P.D. 09-302 CC (formerly P.D. 01-331 CC
Cordova Ridge Planned Development, 4th Amendment

DEPARTMENTAL COMMENTS:

Cordova Ridge P.D. Outline Plan Modification
Response to LRK's comments dated 05-07-09

Gray's Creek Association Mark-Up 1 of 2:

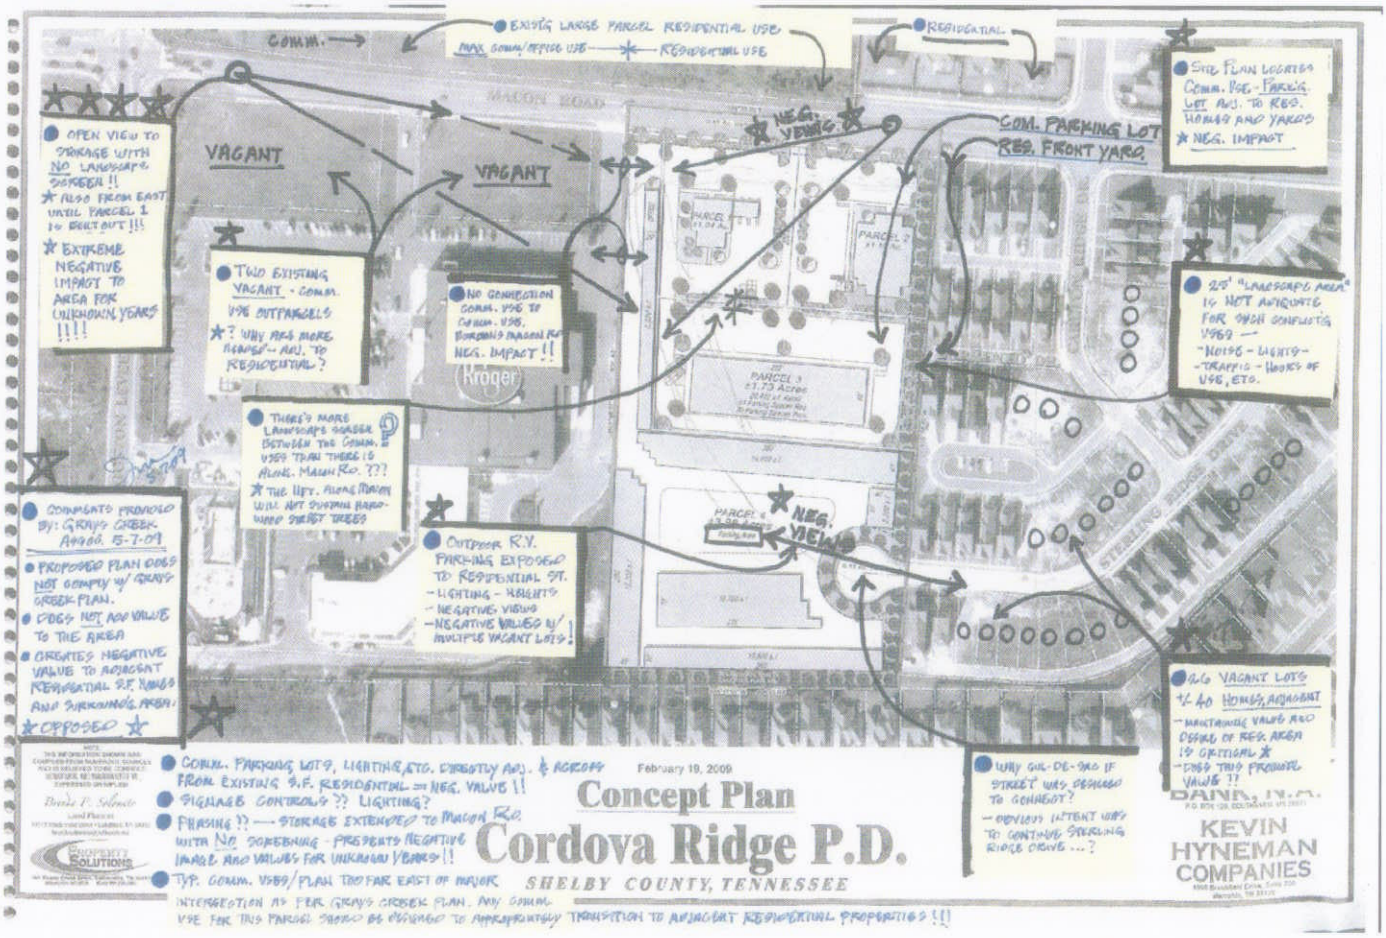
Attached are the mark-ups for the Cordova Ridge application located along Macon Rd.

The first drawing identifies the issues and the second provides one solution which addresses the issues. I had about four different concepts but once I read thru the application and figured out the original plan allows CP uses on this site it seemed like a far reach to ask them to do Residential and given that there are many vacant residential lots adjacent I don't believe this approach would gain us any traction. So with short time available I focused on showing how their basic desires could be achieved with min. changes to their plan.

(1) Comment: *Open view to storage with no landscape screen (traveling east on Macon Road).*

(2) Comment: *Negative view traveling west on Macon Road.*

(3) Comment: *Site Plan locates commercial use parking lot adjacent to residential homes and yards.*

(4) Comment: *25-foot landscaping screen (along east line of parcel) is not adequate for such conflicting uses. Suggest a 40-foot screen.*

(5) Comment: *No connection commercial use to commercial use. Burdens Macon Road.*

(6) Comment: *Minimum 20-foot wide planting area for street scape along Macon Road. 11-feet is too narrow to sustain hardwood street trees.*

(7) Comment: *Extend the front yard setback dimension of the adjacent residential homes into Parcel 2 as a landscape area and plant with hardwoods.*

(8) Comment: *Outdoor R.V. parking area is exposed to residential street creating a negative view.*

(9) Comment: *Why cul-de-sac if street was designed to connect? Obvious intent was to connect Sterling Ridge Drive.*

(10) Comment: *Storage buildings shall not extend (northward) beyond front of building on parcel 3 and in no case ever beyond the side of Kroger.*

(11) Comment: *Does not add value to the area. Creates negative value to adjacent residential single family homes and surrounding area.*

Response: First, the concept plan is sensitive to the surrounding area by using a very narrow entrance on Macon Road. The entry is only 55 feet wide when most mini-warehouse developments use 100 feet or more.

Second, it is not typical to install heavy landscape screening between adjacent commercial uses. Once the vacant out parcels in front of Kroger along Macon Road develop, the sight lines as sketched will be blocked. It would be very short sighted to impose the burden of a commercial-to-commercial landscape screen to address a temporary aesthetic sight line concern.

Third, the proposed architecture for the mini-warehouse buildings calls for all masonry construction and will be more attractive that the existing commercial construction.

Fourth, All of the proposed landscaping and the Macon Road streetscape shown on the concept plan meet or exceed the requirements set forth in the approved planned development and ZTA 96-002CC(ordinance specifically addressing mini-warehouse developments).

Response: Again, the proposed architecture for the mini-warehouse building elevations will be all masonry so the view while traveling west on Macon will effectively be a brick wall with an eight-foot evergreen screen in front. This would not create a negative view looking west into the site.

Response: Parcels 1, 2, and 3 are not a part of this application and are shown on the concept plan for illustrative purposes only. Parcel 4 is the only portion of the property for which the additional mini-warehouse use is being added. The balance of the property (Parcels 1, 2, and 3) will remain as previously approved. It should be noted that the 25-foot landscape screen (with sight proof fence) shown along the east boundary of Parcels 2 and 3 is 10-feet wider than the 15-foot screen required by the approved planned development and meets the specifically referenced landscape requirement in ZTA 96-002CC.

Response: See response to Comment (3). The applicant is opposed to a 40-foot landscape screen along the east line.

Response: The concept plan absolutely does connect the subject parcel with the commercial parcel adjacent to the west (Kroger). The existing drive located on Macon at Kroger's east line will be shared with and provide access to the site.

Response: Standard plate A-3 is required by the approved P.D. and has been the typical requirement for many years. The applicant is opposed to the placement of arbitrary requirements or conditions on its property.

Response: The applicant is opposed to this 'taking' of its property.

Response: The fully developed cul-de-sac shown on the concept plan is superior to the undersized patch of asphalt that currently exists. The residents currently have a view of the rear of the Kroger store.
The concept plan proposes the planting of a 25-foot wide landscape screen completely around the head of the cove. The screen will include a sight proof fence. This plan represents a dramatic improvement of the existing condition.

Response: The adjacent neighborhood (Cordova Ridge P.D. Phase 7) is only 11.2 acres in size and was originally designated for office uses. When it became apparent that the demand for office along this portion of the Macon corridor was low the County allowed this property to be rezoned for residential uses. Please note that this subdivision has no connectivity to any of the surrounding neighborhoods and has two points of access to Macon Road.

Any extension of Sterling Ridge Drive through the subject commercial property would damage and potentially destroy it's viability for commercial uses without accomplishing any meaningful connection to the Kroger site. Due to the location of Kroger's detention pond Sterling Ridge Drive cannot be extended to the west and creating another public street intersection in Macon Road east of the Kroger site would be expensive, effectively pointless and extremely disruptive to the orderly development of the applicant's site.

Response: This condition is unacceptable because it provides no presence along Macon Road for the mini-warehouse site. Additionally, the alternate site configuration presented is not practical because it does not allow for ingress and egress of moving vehicles into and out of the storage facility without driving through parking lots designated for service to the retail component of the development. The alternate site plan does not appear to provide proper turning radii to accommodate typical moving vehicles.

Gray's Creek Association Mark-Up 2 of 2:

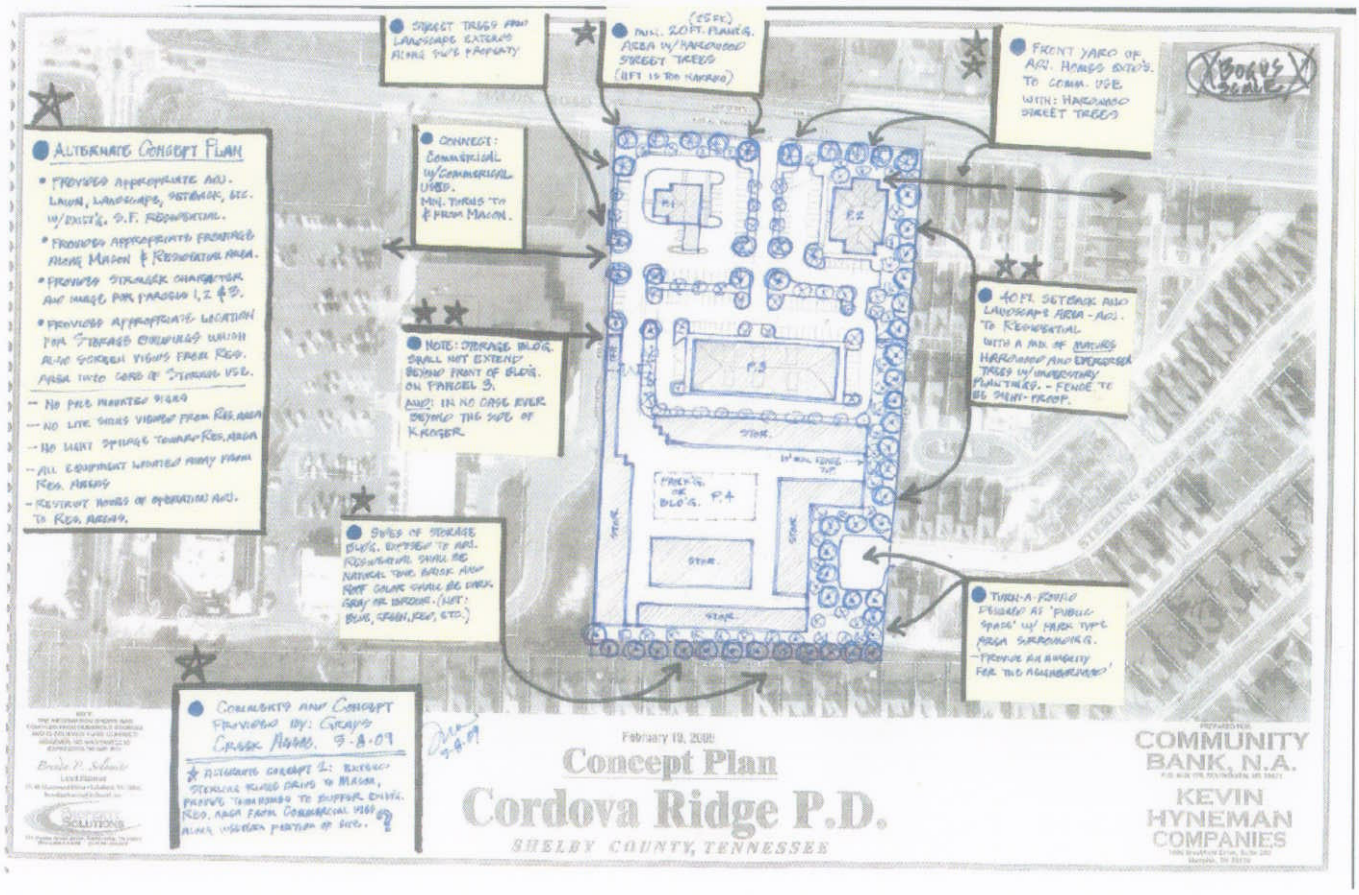
The parking lot in front of parcel 2 which is adjacent to the existing residential area will create a negative situation for these homes. The revised concept plan addresses this and should be a requirement of approval.
